APPLICATION NO.	FILING DATE	FIRST NAMED INVENTOR	ATTORNEY DOCKET NO.	CONFIRMATION NO.
10/647,726	08/25/2003	Karren Moreland	43	2147
26362 7590 07/17/2007 LOUIS J. HOFFMAN, P.C. 11811 North Tatum Boulevard, Suite 2100 Phoenix, AZ 85028			EXAMINER FERGUSON, MICHAEL P	
			ART UNIT 3679	PAPER NUMBER
			MAIL DATE 07/17/2007	DELIVERY MODE PAPER

Office Action Summary	Application No. 10/647,726	Applicant(s) MORELAND ET AL.	
	Examiner Michael P. Ferguson	Art Unit 3679

DETAILED ACTION

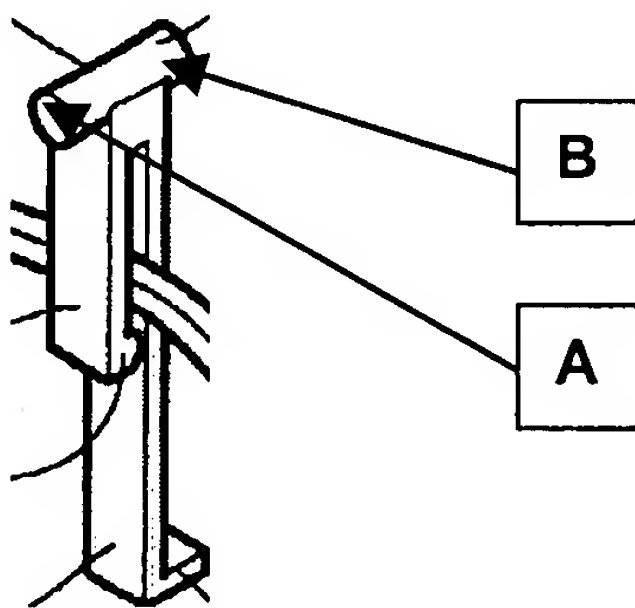
As to claim 17, Moreland discloses a lock wherein, measured along the intersection of the body **82** and a plane passing through the neck **84**, a first side **A** (Figure 2 reprinted below with annotations) of the body adjacent to the neck is wider than an opposing side **B** of the body (Figure 2).

As to claim 26, Moreland discloses a system wherein, measured along the intersection of the body **82** and a plane passing through the neck **84**, a first side **A** of the body adjacent to the neck is wider than an opposing side **B** of the body (Figure 2).
